Town of Kittery
Planning Board Meeting
November 17, 2016

74 State Road – Sketch Plan Review

Action: Accept or deny application. Approve or deny sketch plan. Owner PB 'R' Us, and applicant, Christopher Baudo request consideration of a mixed use complex located at 74 State Road (Tax Map 8 Lot 41A) in the Business Local (B-L) Zone.

Existing Conditions Plan

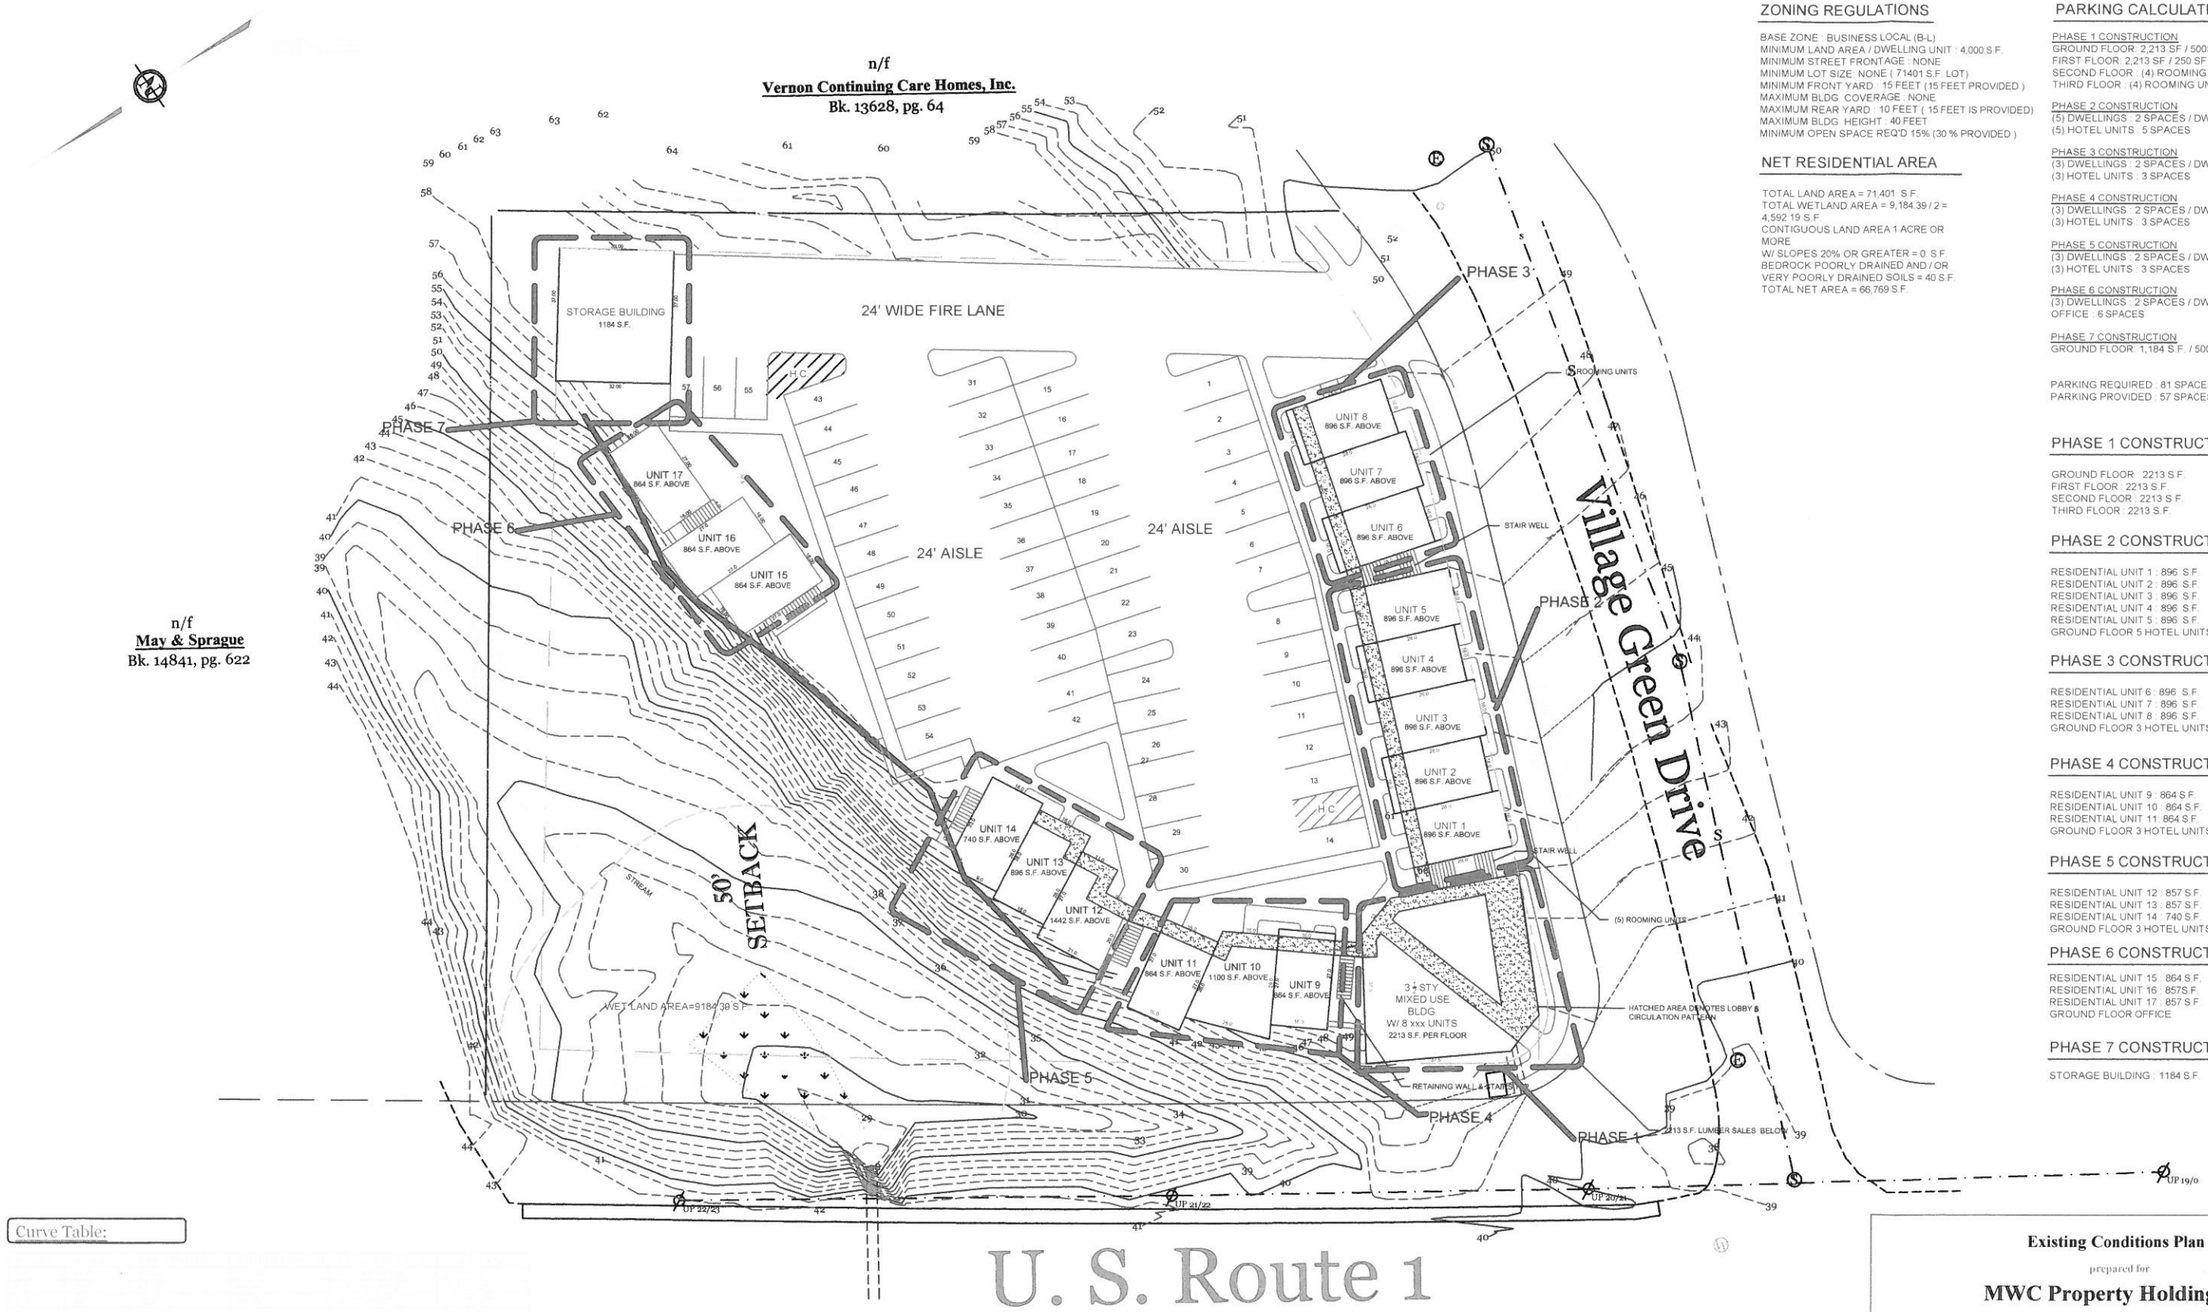
2. The sketch plan is incorrectly titled "existing conditions plan". The proposed lot is vacant.

3. All structures must conform to the building design standards outlined in 16.3.2.8.D.1.b, including designing the street façade as the front of the building. The applicant has submitted a design sketch only for the 3.5-story mixed-use corner building, which appears to comply with this standard. The sketch appears to depict the primary access to the hotel rooms/town house units from the parking lot area. The applicant must design the street-facing side of the building as the

"front" of the building with either a "front door", window or display case. The applicant should review the design handbook, Section II, Façade Design.

5. The sketch plan refers to "rooming units" in reference to the second and third floor units in the corner building. The code does not have a separate definition of a "rooming unit"; therefore, the Board should discuss whether these units should be reviewed as dwelling units, or, whether the upper two stories of the corner building can be considered a "rooming house", per the definition in 16.2.2, with 8 individual rooming units. When making this determination, the following should be taken into consideration:
    a. The applicant expressed plans to have a manager reside onsite and oversee the units.
    b. Per the definition of dwelling unit in 16.2.2, a dwelling unit must be a minimum of 650 square feet. It appears the total floor area of the second and third floor of the corner building is 2,213, which would average only 553 square feet per unit (2,213/4).

6. The forth story of the proposed corner building is listed as a half story, in order to conform to building height standards. However, the sketch plan depicts the same number of units as the 3rd floor. It is unclear whether a forth, "half story", would be large enough to support four dwelling units. The applicant should elaborate and clarify for the Board to consider the feasibility of the proposed design.

7. The minimum land area per dwelling unit is 4,000 square feet, if served by public sewer (as is the case with the proposed development) and the entire first floor is used for nonresidential uses. The sketch plan depicts the total Net Residential Acreage (NRA) as 66,769 square feet, which supports 16 units. If the Board determines the upper stories of the corner building is a rooming house, then an NRA to support a total of 18 units (17 town houses and one rooming house with 8 rented rooms) is required. If the Board determines the units are individual dwelling units, an NRA to support 25 units (17 town houses and 8 apartment-style dwelling units) is required. The available NRA does not appear to support either of those scenarios. In order to conform, the applicant may want to consider converting the 8 rooming/dwelling units to additional hotel rooms, and reducing the total number of proposed town houses from 17 to 16.

9. In addition to the minimum front yard setback, the Business-Local Zone has a 60-foot *maximum* front yard setback for all principal structures. Per the definition of corner lot, the side yard between the principal building and the side street, as determined by the street that does not provide legal frontage to the lot, may not be less than the front yard requirements. Therefore, the maximum front yard setback applies to both Route 1 and Village Green Drive and all principal buildings may not be located further than 60-feet from the street(s).

a. The building labeled units 15-17 is a principal structure (containing three office spaces and three townhouse residences) located further than 60-feet from Village Green Drive, and therefore not permitted.

10. The sketch plan does not identify any preserved open space. The applicant informed Staff they intend to utilize the northern corner of the property for open space. The required open space standard for the B-L zone is 15% (10,711 s.f.) of the total lot area. Open space "must be located to create an attractive environment on the site, minimize environmental impacts, protect significant natural features or resources and maintain wildlife habitat".

12. It is evident that a great amount of ledge is on site that will require removal as part of the proposed development. Per the submitted design drawing, it appears the applicant intends to have the corner building level with the intersection of State Road and Village Green Drive. The sketch plan appears to show the majority of the development on top of the existing ledge on site. It is not clear how the applicant plans to transition the grade within the development.

13. The easterly property line is also a zone boundary between the Business Local and Residential-Urban zone. Where the Business Local zone abuts a residential district, the minimum side and rear yards of 15-feet or 50% of the building height are required. It appears the sketch plan depicts side/rear setbacks of 10-feet. An increase in the easterly setback may impact the location of the storage building. Parking areas are permitted within rear and side yard setbacks.

15. The parking lot design has only one entry/exit point accessing Village Green Drive. There does not appear to be another location for a secondary exit on site. However, the development may benefit from a more ample dead end terminus that would allow easier turn-around movement for both passenger and emergency vehicles.

16. The sketch plan includes two accessible parking spaces. Accessible parking spaces must be an area at least 19-feet deep and 8-feet wide, and abut a designated 5-foot wide isle for passenger and 8'-wide for a van accessible space. The sketch plan does not to depict this; one space does not conform to the specified dimensions and both are missing the required 5-foot wide isle. In addition, the required minimum number of accessible spaces in a 57-space parking lot is 3 (1 van, 2 passenger) while the sketch plan only depicts 2.

17. Parking Calculations
    a. The parking calculations on the plan totals 81 required parking spaces for the proposed development, however, only 57 are depicted on the sketch plan.
    b. Without more information, it is difficult to confirm the required parking on the plan aligns with the standards outlined in 16.8.9.4, off-street parking standards, which include:
        i. Dwellings: 2 parking spaces per dwelling unit
        ii. Hotels: 1 parking space for each rental unit plus 1 space for each 100 square feet of meeting room (14 spaces and an additional space per 100 square feet of lobby)
        iii. Offices: 2 parking spaces for each office unit plus 1 space for each 250 square feet of gross floor area
        iv. Warehouse and storage: 1 parking space for each 500 s.f. of gross floor area

The Board may want more information from the applicant on program details and rationale for providing less than the required parking spaces prior to approving the sketch plan. If not, the applicant should resolve any inconsistences and total required parking must be recalculated, and possibly redesigned, prior to the submission of a preliminary plan application.

18. A vegetated landscape planter strip is required adjacent to both State Road and Village Green Drive. The sketch plan does not depict a planter strip along either road. In addition, a minimum of one tree is required for each 25 feet of street frontage. A landscape plan depicting both a planter strip and required tree plantings must be included with the submission of a preliminary plan application.
